**KILDARE COUNTY COUNCIL
PLANNING DEPARTMENT**

Type of Development	Public Realm Improvement Works
Site Location	Market Square, Kildare Town
Development proposed by	Strategic Projects and Public Realm
Display period	<p>Advertised in the Leinster Leader and Kildare Nationalist published 16th January 2024.</p> <p>Public display period from 17th January to 29th February 2024.</p> <p>Submissions could be made by 29th February 2024.</p>
Submissions/observations	<p>48 No. submissions received.</p> <p>A report on the submissions is included in Appendix A. A list of people who made submissions/observations is provided in Appendix B</p>
Part 8 Reference Number	P82023.08

Report prepared in accordance with Part 8, Article 81 of the Planning and Development Regulations 2001 (as amended) and the Planning and Development Act 2000 (as amended).

Figure 3: Distances from Proposed Loading Bay on Market Square East

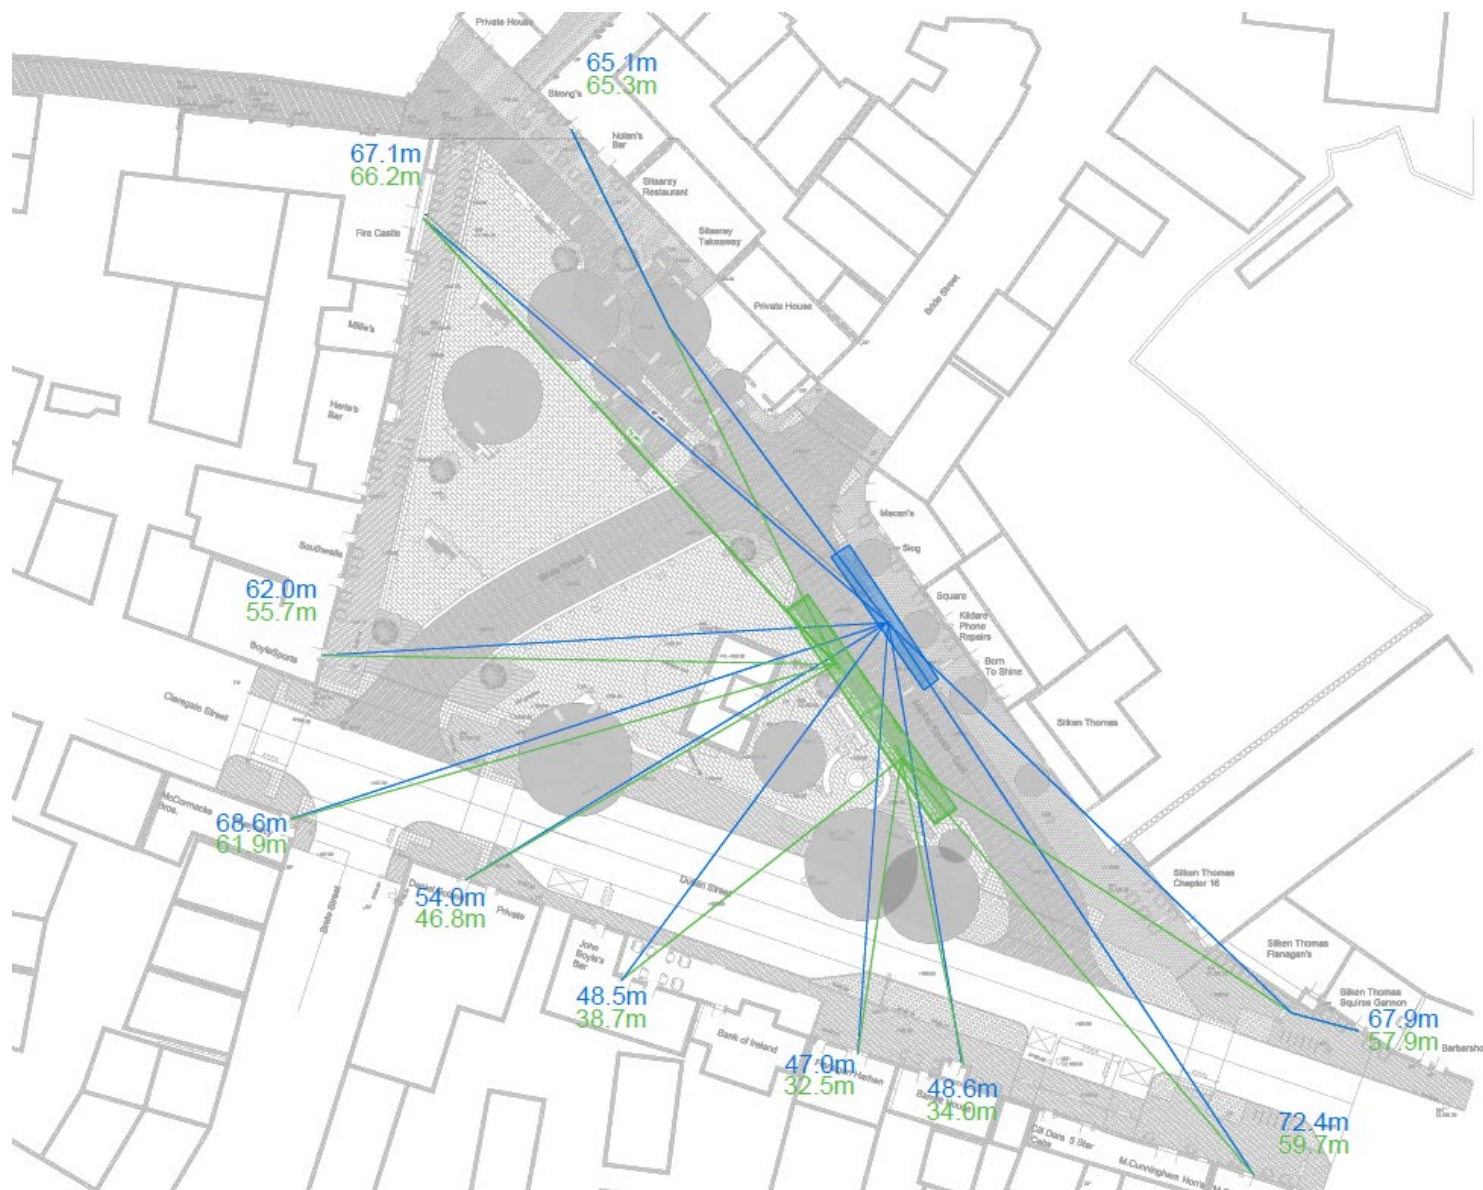
- The primary objective of a loading bay is to provide an area for loading and unloading facilities for businesses (commercial vehicles only).
- Where appropriate they should not interfere with traffic or pedestrians.
- They should be positioned to facilitate more than one business.
- Loading bays are installed in areas where the parking of private vehicles interferes with the loading/unloading of commercial goods. They operate during specified hours. Outside of these hours the bays revert to parking bays or they may also be shared with, for example, a taxi rank or pay and display parking.

The existing loading bay for Market Square is located on Market Square East adjacent to Square Coffee. The current location is close to the approximate geographical centre of the square in respect of delivery distances to each of the 25+ business units within the Market Square area. As part of the proposed work, it is intended to relocate the loading bay to the opposite side of the Market Square East. The objective of the proposed relocation is to provide the businesses on the north side of the square with a wider more pedestrian orientated footpath space with the capacity to be developed as an outdoor dining/meeting space while simultaneously retaining the loading bay at the geographical centre of the square. The central location of the bay has a significant importance in providing a delivery platform that is considered equal and fair to all existing and future business stakeholders within the Market Square area.

KCC explored the possibility of locating a loading bay on the west side of Bride Street but it has been omitted for the following reasons:

- Location is not central to the Market Square to facilitate the servicing of all business units equally.
- Autotracking for rigid type delivery trucks highlights difficulty in maneuvering into a loading bay of standard depth.
- Required maneuvering of rigid vehicles from Dublin Road junction will interfere with flow of traffic through signaled junction at peak hours when junction is at capacity.
- Where appropriate loading bays should not interfere with traffic or pedestrians (Kildare County Council Taking in charge Policy 2023, Appendix 13).

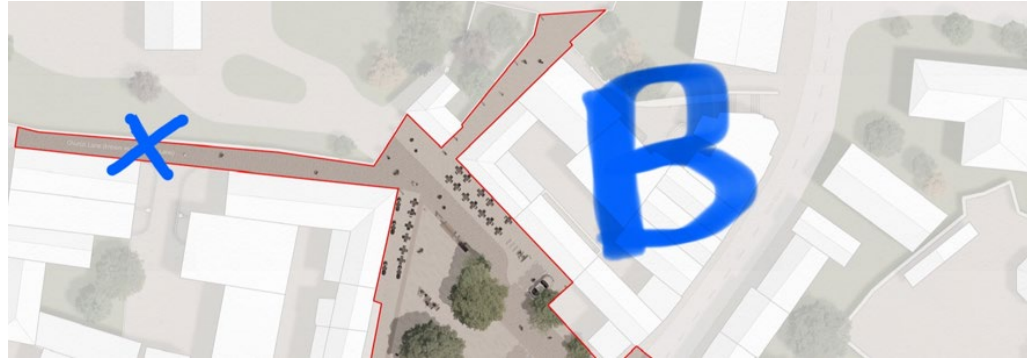
4. The existing bollards which are located at the bottom of Firecastle lane (Please see map (B)) should be replaced by electric bollards and ramps should be installed outside the small cottages for the safety of the residents and pedestrians. This will facilitate health and safety in the case of an emergency for the business as-well as the residents located along Firecastle Lane.

5. The new bollards proposed by the council at the chemist - Our main concern is how are they to be controlled and operated? Because we operate a home delivery service from 5pm daily and have been doing so for 40+ years, we are worried about how our drivers are to operate safely and undisrupted? Our suggestion is that after 5pm that either these bollards or the other bollards (marked in blue on map (B) be left down until our business closes at 11pm. This is only by way of a compromise but frankly we feel that these new bollards are unnecessary if the double yellow lines are continued down the lane and are properly enforced. Currently there is no enforcement being carried out which leads to a lot of confusion and unauthorised parking and results in the right of way being blocked continuously.

<p>The enforcement of road traffic regulations is a matter for An Garda Síochána, with powers also provided to KCC in respect of Community Wardens who have a dual role of traffic and litter duties between the hours of 9am to 5pm Monday to Friday inclusive. This submission has been noted by KCC Roads, Transportation and Public Safety Department.</p> <p>Refer to Section 5.1.5 re bus and coach parking.</p> <p>Suggested Changes to the Part 8 Project</p> <ol style="list-style-type: none"> 1. Refer to Section 5.1.6 - Market Square East 2. A new uncontrolled pedestrian crossing has been proposed in the proposed Part 8 Project between Mc Hugh's Chemist and Market Square East 3. Refer to Section 5.1.2 - Provision of Loading Bays 4. Refer to Section 5.1.7 - Retractable Bollards. 5. Refer to Section 5.1.7 - Retractable Bollards. It should also be noted that exit bollards (i.e. Map B) can be installed with a magnetic loop system which will activate the bollard when approached by a vehicle. As per Section 5.1.7, functionality of the bollard will be agreed at detailed design stage.

6. Signage will be agreed at detailed design stage.

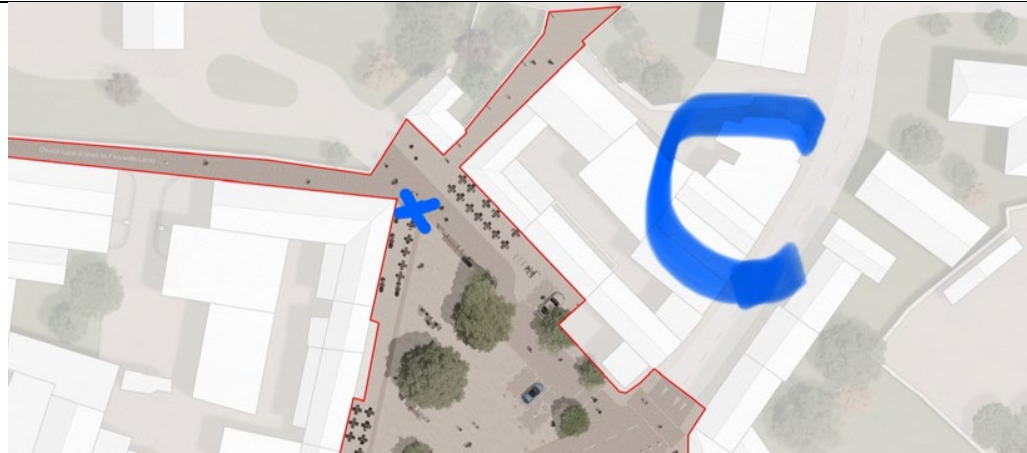
9. The very high and obstructive footpath located outside fire castle Business should be removed immediately - Please see map marked (C) - Again this is a health and safety issue which has not only caused a lot of damage to vehicles but obstructs the safe passage for fire trucks, ambulances, delivery vehicles etc. As can be seen in the image attached, this was the original footpath and yellow lines that continued down the lane. The following image shows the new footpath which is clearly a health and safety issue and poses a threat to the public and the access to our business in the event of an emergency.

10. The area that was pedestrianised a number of years ago, where 15 (approx.) car parking spaces existed - please see map (D) - tourist office location - is very large and unused. Perhaps a portion of this space could be utilised to widen the road to allow the free flow of traffic which can get very congested especially when vehicles need to turn right going towards Claregate street. "Strategically located car parks within five minutes walking distance to the town centre" can you please confirm exactly where these car parks are located?

9. The footpath located outside Firecastle will be addressed at detailed design stage. It is intended to provide a level surface throughout Market Square North by means of kerb removal and regrading of the square to proposed levels
